CITY PLAN COMMISSION STAFF REPORT

CD-CPC-2025-00081, -00080, -00082

Bungalows at Maple Woods

Corrections Report

OVERALL SITE PLAN

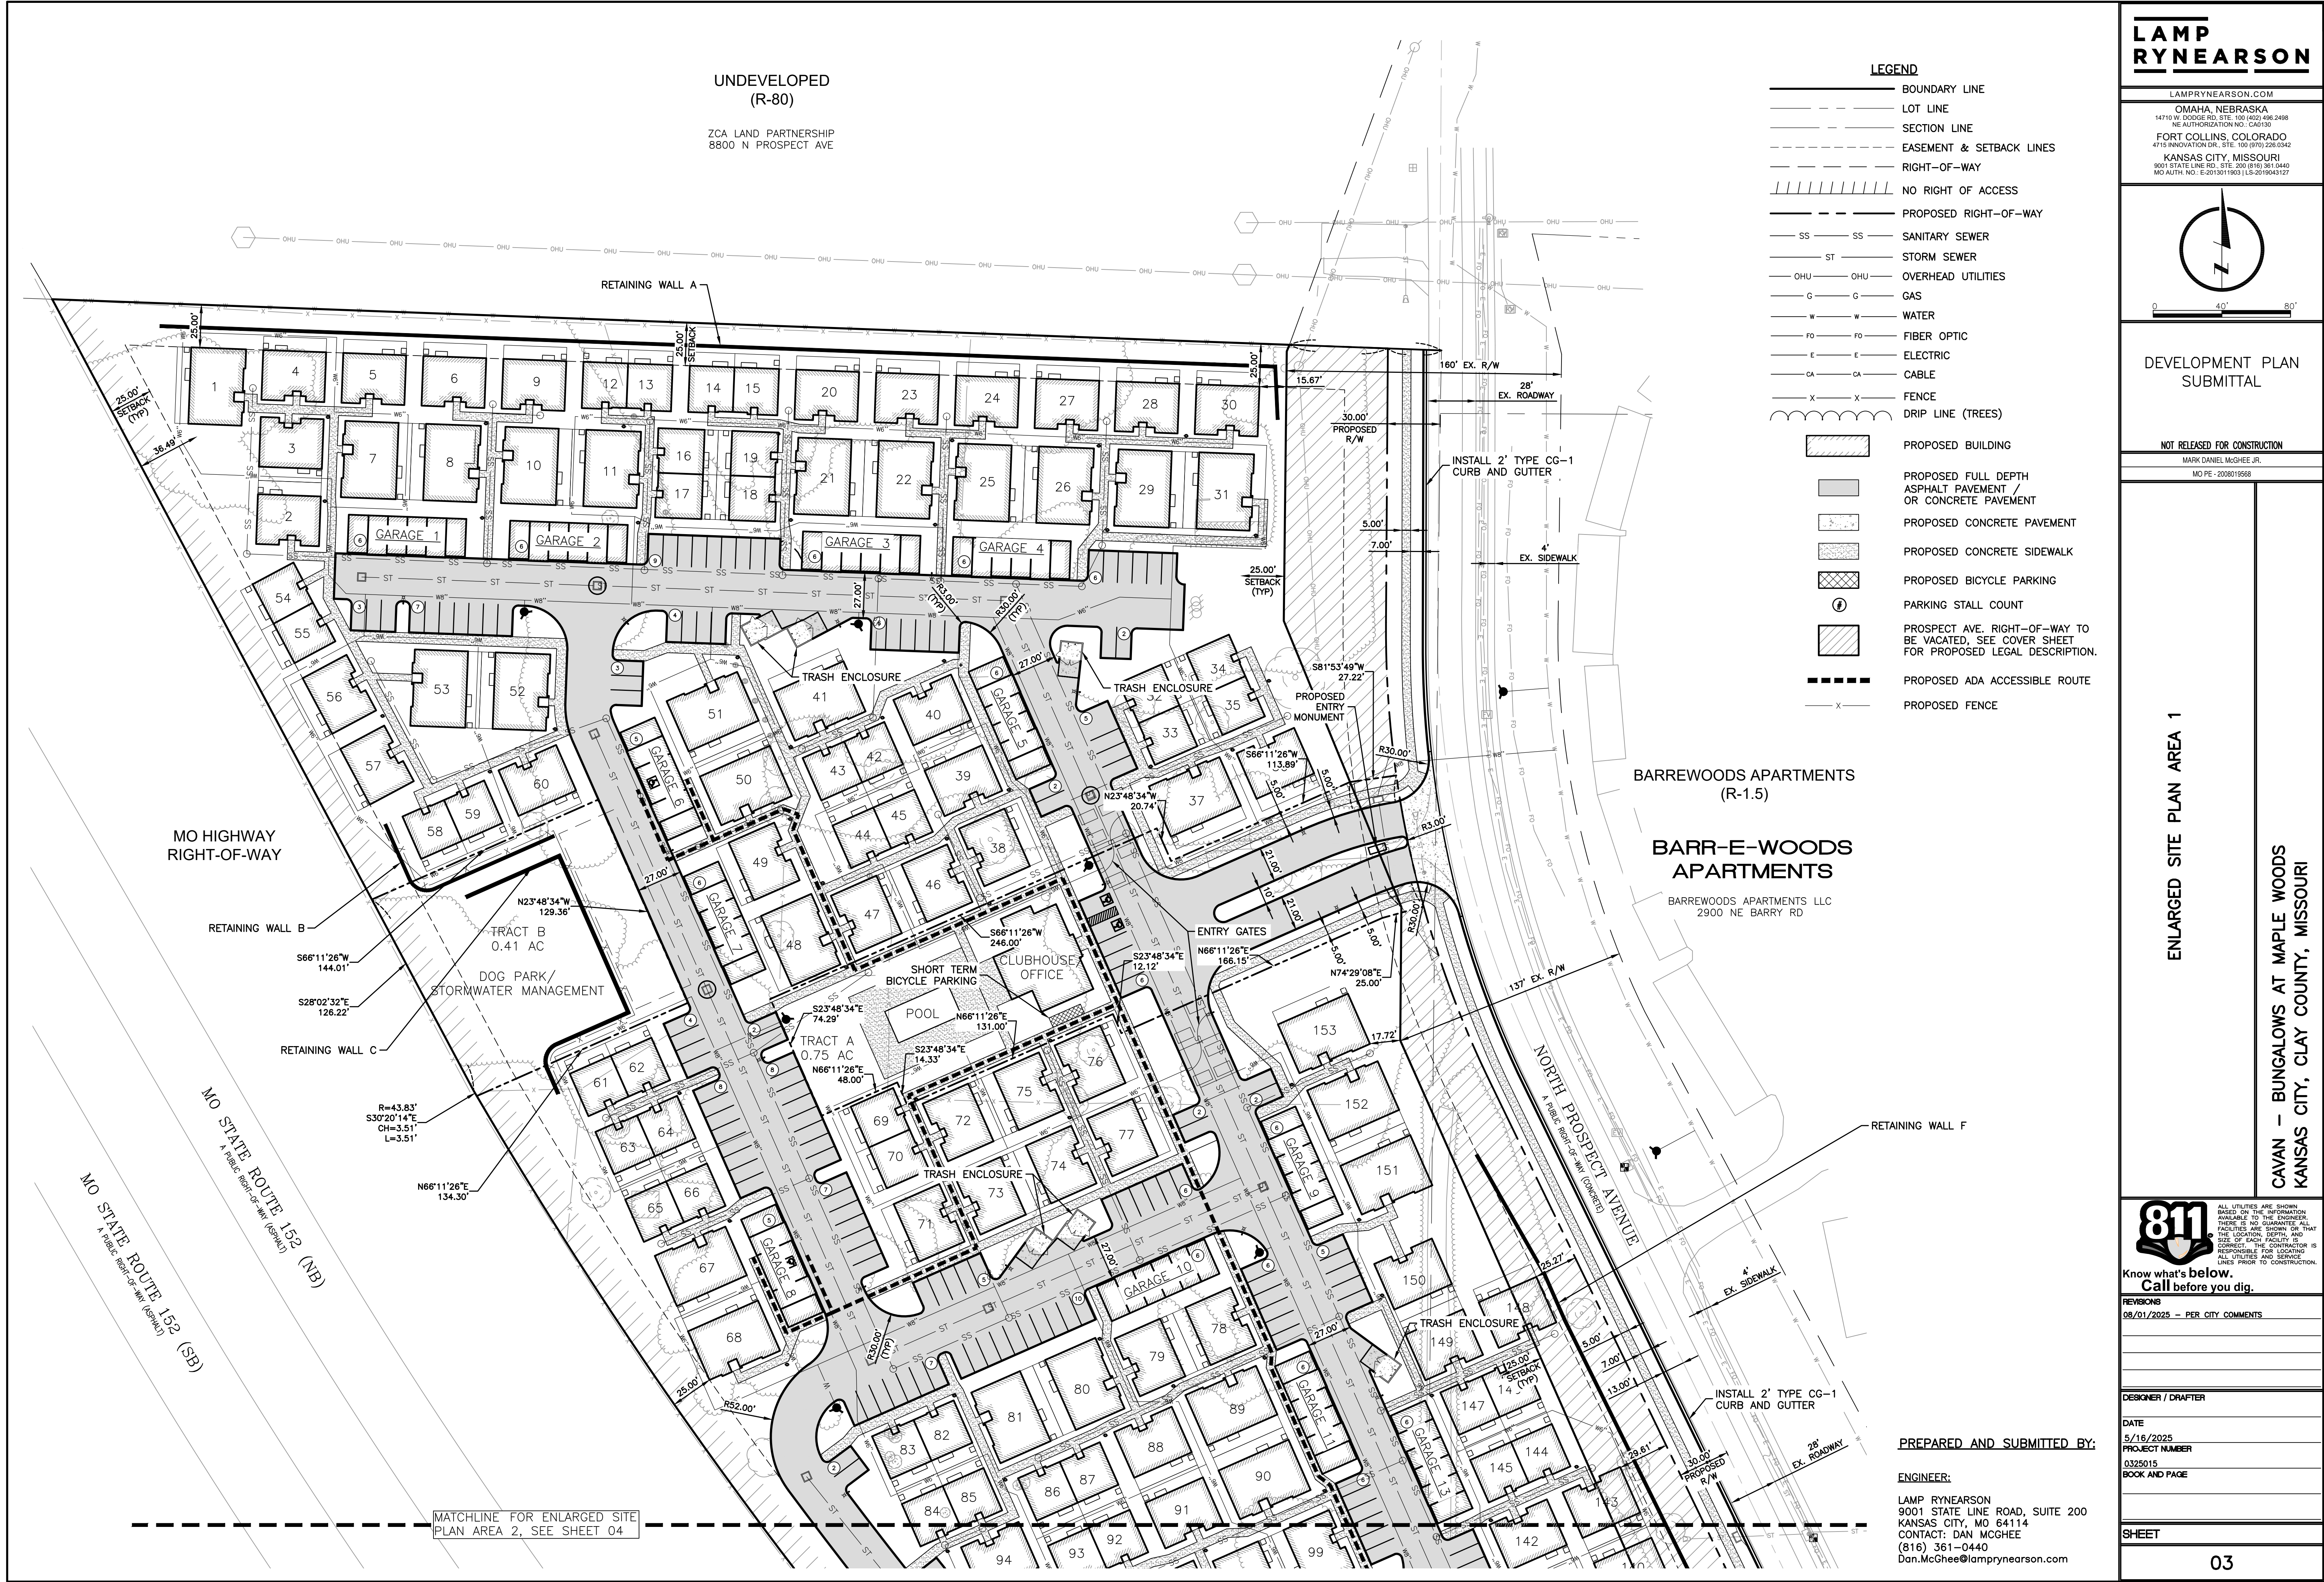
3. Please update the Parkland Dedication table on sheet 02. All two and three bedroom buildings are classified as detached residential with a person/unit ratio of 3.7. The one bedroom units are classified as semi-attached residential with a person/unit ratio of 3. This would update the total acreage required to 3.05 (8/04/2025)
